Pre-lodgement Meeting Notes

Application No:	PLM2023/0094
Meeting Date:	10 August 2023
Property Address:	280 Condamine Street MANLY VALE
Proposal:	Alterations and additions to a residential care facility (New driveway and Porte Cochere)
Attendees for Council:	Jordan Davies – Acting Manager Development Assessment Mia Mia Battisti - Student Town Planner

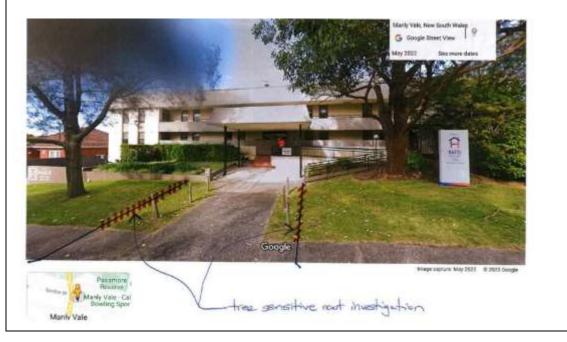
The works are in proximity to existing native trees that appear is good health and condition and these shall not be impacted by the works.

An Arboricultural Impact Assessment report prepared in accordance with Council's DA Lodgement requirements shall be submitted and report on:

- > impacts to the tree canopies from building works,
- > impacts to existing tree roots from widening of the crossover driveway.

To assist determination of the impact to existing roots it is advised that a sensitive tree root investigation be conducted along the extent of proposed excavation works for the crossover driveway, as per accompanying sketch.
